The Glaring Problem with Witherspoon's New Lights

Executive Summary

The new Granville GVD3 Holophane lights on Witherspoon, 2025 December.

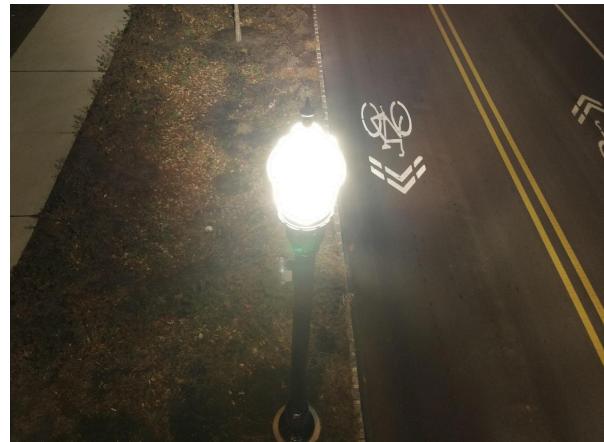
The recently installed GranVille LED Post-top Acorns lights on Witherspoon Street are **highly light-polluting fixtures, with an estimated 46% of the light wasted (glare + uplight), and are incompatible with any modern sustainability and environmental principles**, including Princeton's municipal code. The Witherspoon Street Improvement Project's lighting plan was based on the seriously outdated (12 year old) ANSI/IES RP-8-14 code, reflecting an early LED-transition framework not adequately addressing backlight, uplight and glare (BUG), or the impacts of blue-rich light, whereas more recent IES guidance and best practice emphasize full cutoff fixtures, reduced high-angle luminance, and warmer color temperatures—often 2700 K or lower—particularly in residential and historic contexts. The new lights are **blindingly harsh, causing a glare that poses a safety risk, as** recognized in recent lighting and vision studies. Their BUG rating (0 being best, 5 being worst) of 2-4-4 is grossly incompatible with modern sustainability and environmental practices, where U0 lighting is a solid standard, and backlight/glare is preferred at 0 or 1. The new lights are **predominantly blue (4000K), contrary to health recommendations from hundreds of peer-reviewed articles over the past two decades, which have linked long-term adverse health effects to such lighting**. Based on extensive photometric measurements, the new fixtures overlight the area multiple times, creating excessive contrast between Witherspoon and its side streets. The blinding of pedestrians as they turn onto Witherspoon and the disruption of night vision as they enter the side streets are again security concerns. Because of the lack of shielding, the buildings on both sides of Witherspoon are floodlit. The added glow from Witherspoon is now measurable as excess sky brightness at night from Princeton's golf course.

The fixture selection aims to preserve Princeton's historic character, but the Granville Holophane falls short in overall effect. The **new lights do not match Princeton's historic ambiance**, which was warm in color, modest in intensity, and directed downward to illuminate the roadway and sidewalk while leaving buildings, trees, and the night sky largely unlit. Most importantly, classic gas-lit fixtures were shielded on the top, and their color temperature was around 2000K, generating an atmosphere that felt intimate, calm, and cohesive. Their light output ranged from 100 to 500 lumens. By contrast, the new unshielded, high-intensity, cool (4000K) lighting conveys a stark, utilitarian character more typical of service or loading areas with an output of 5,500 lumens (10 to 50 times the brightness of historical lights). Details of the fixture are invisible at night, as they are too bright to see any of their features.

Obviously, the situation must be remedied on a short timescale. I suggest two ways forward.

As an immediate action item, before retrofitting, all light fixtures could be dimmed to 25% of their current brightness to avoid the ongoing damage to the environment and the ambiance. Alternatively, they can be turned off until the retrofitting is complete, returning the area's light levels to those present for many decades without these lights, which I measured at 0.2-0.4 FC on the sidewalks and 0.4-0.6 FC on the roadway, conforming to the lower value of Princeton's code based on IESNA standards (crosswalks were already all far in excess of 1 FC illuminance *without* the new lights, often at 2 to 4 FC).

RETROFIT OPTION 1. Replace all fixtures with PSEG's **Epic Medium fixture**, which is a decorative pendant-style outdoor luminaire designed for streets, parks, and urban spaces, and has a BUG rating of B1–U0–G1, i.e., full cutoff of uplight (U0). **It is an excellent light fixture with a wide range of modern, sustainable, safe, and healthy options, including warm color temperatures of 2200K (amber) and 2700K, dimming options, and retrofit adapters.** Later in this report, I provide a template letter to PSEG requesting this specific retrofit.

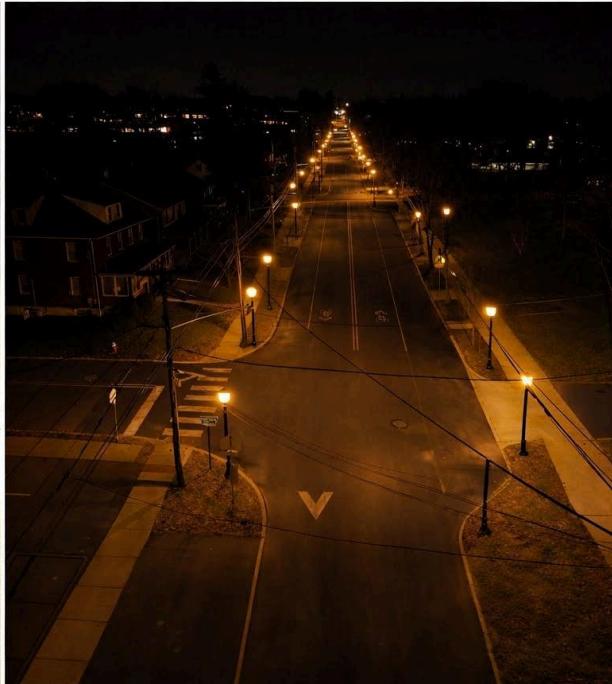
*A realistic simulation demonstrating the effect of the proposed retrofit from the current fixtures (left, photo taken in December 2025) to the **Epic Medium fixture, full cutoff, 2700K (simulated rendering)**. This proposed retrofit would achieve zero uplight, i.e., a BUG rating if U=0. Notice the significant difference in light trespass: the houses remain dark, while the sidewalk is well lit.*

*A realistic simulation demonstrating the effect of the proposed retrofit from the current fixtures (left, photo taken in December 2025) to the **Epic Medium fixture, full cutoff, 2700K (simulated rendering using IES files)**. This proposed retrofit would achieve zero uplight, i.e., a BUG rating if U=0. The area remains well-lit, with significantly improved visibility due to reduced glare.*

Approximate P10 with 2700 K + FC + house-side shield retrofit

Spectrophotometric measurements on the sidewalk, moderately close to a light fixture.

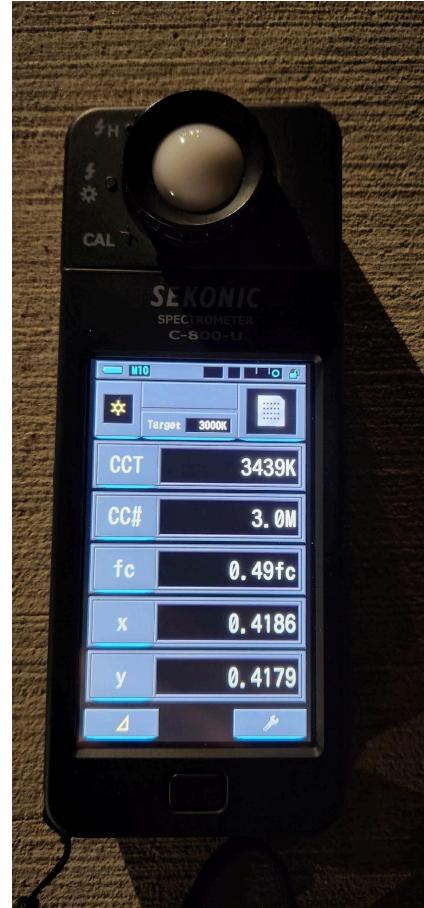
The illuminance is 0.65FC, which is about 2-3x brighter than the IESNA recommendations for minimum sidewalk lighting. The overall spectrum is blue, with a significant, harmful spike at 430nm. (While we don't directly sense the spike, as it is overwhelmed by the less blue light, it is present, and is harmful for e.g. melatonin production, and also causes strong atmospheric scattering).

Spectrophotometric measurements on the sidewalk, at the darkest possible location, in between poles, and as far as possible from streetlights.

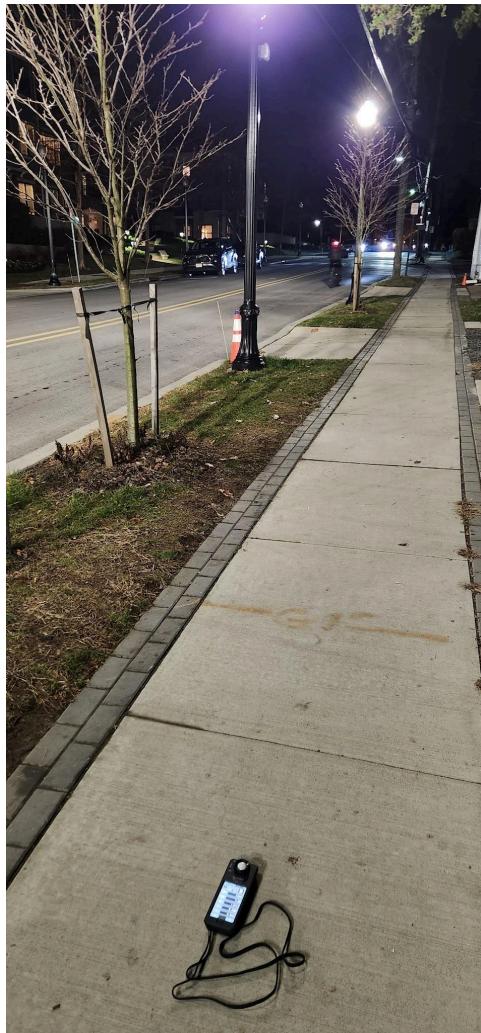
The illuminance is 0.5C, approximately 2x the IESNA recommendation for minimum sidewalk lighting.

Spectrophotometric measurements on the sidewalk, at the brightest possible location, with illumination coming from both sidewalk and streetlights.

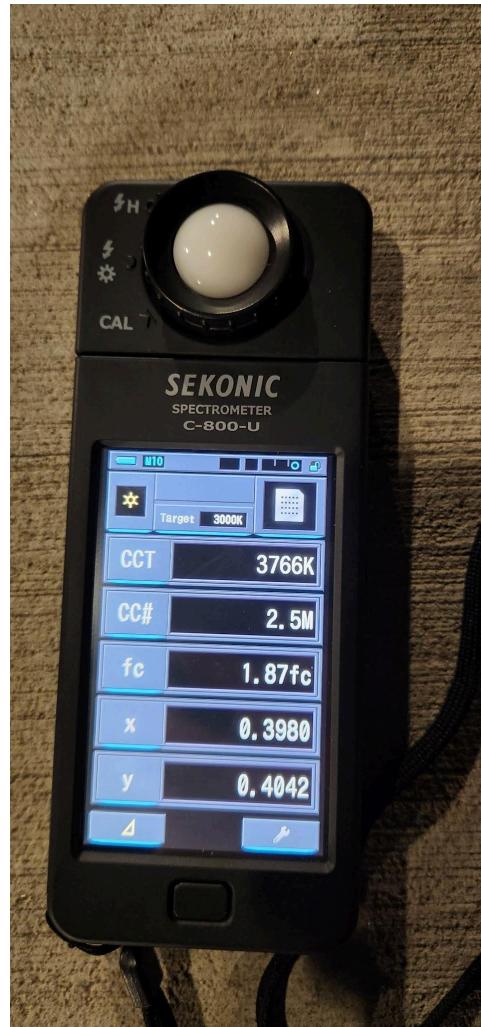
The illuminance is 1.9FC, which is about 7-8x brighter than the IESNA recommendations for minimum sidewalk lighting.
